**PLANNING DIRECTOR'S SPECIAL PERMIT
FOR SINGLE FAMILY RESIDENTIAL IN A PUD**

FILE: P99-071

PROJECT NAME: Renaissance Homes in Northpointe Park - Village 12

**RE: Design Review - Lennar Renaissance, Inc. – Natomas Park
Northpointe Park Village 12**

PLAN 655 - MONTEREY FRONT ELEVATION A
OPTION 4 & 5

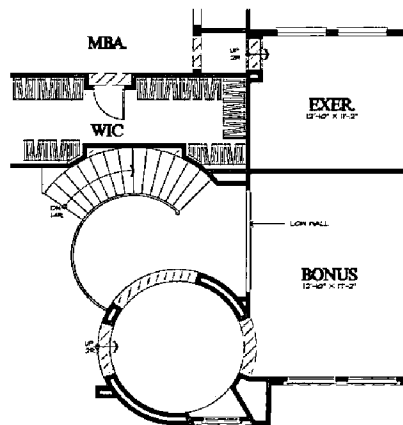
1. We recommend that any roof projections (i.e.: vents, pipes) be located in the back of the home, not visible from the street.
2. On the Plan 653 with the Monterey style elevation, we would like to suggest that you consider changing the style of window for the upper bath to the same style as the Plan 653, elevation B.
3. Please clarify the gable treatment on Plan 654, elevation B.
4. Please clarify if a door to the outside is missing from the single car garage on Plan 655.

PLAN 652 - MONTEREY FRONT ELEVATION A

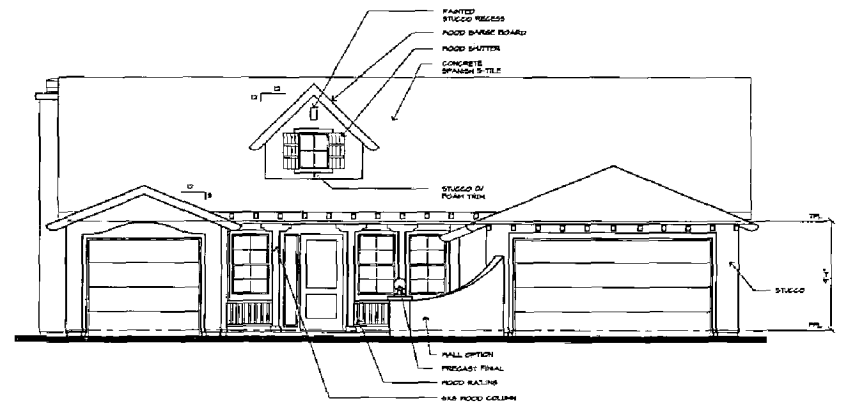
Plan 652: Planning staff is concerned about Plan 652 because: 1) no living area faces the street unless the third car garage is converted into living area and 2) the majority of the front elevation is devoted to the garages. Planning staff would suggest the following conditions be required for Plan 652: 1) A maximum of 50 percent of all the Plan 652 homes throughout Village 12 may be constructed with the three car garage option; and 2) Plan 652 shall be allowed on interior lots only unless the third car garage is converted to living area. The applicant has agreed to these conditions. If compliance with the 50 percent maximum 3 car garage condition on Plan 652 proves infeasible as the homes are built, the home builder can request a modification to the condition through a Planning Director's Special Permit Modification. Planning staff will work with the applicant on such a request and the Planning Director may approve, modify, or deny the requested condition change.

- b. A maximum of 50 percent of all the Plan 652 homes throughout Village 12 may be constructed with the three car garage option;
 - c. Plan 652 and Plan 653 shall be located on an interior lot only unless constructed with living space in the third car garage;
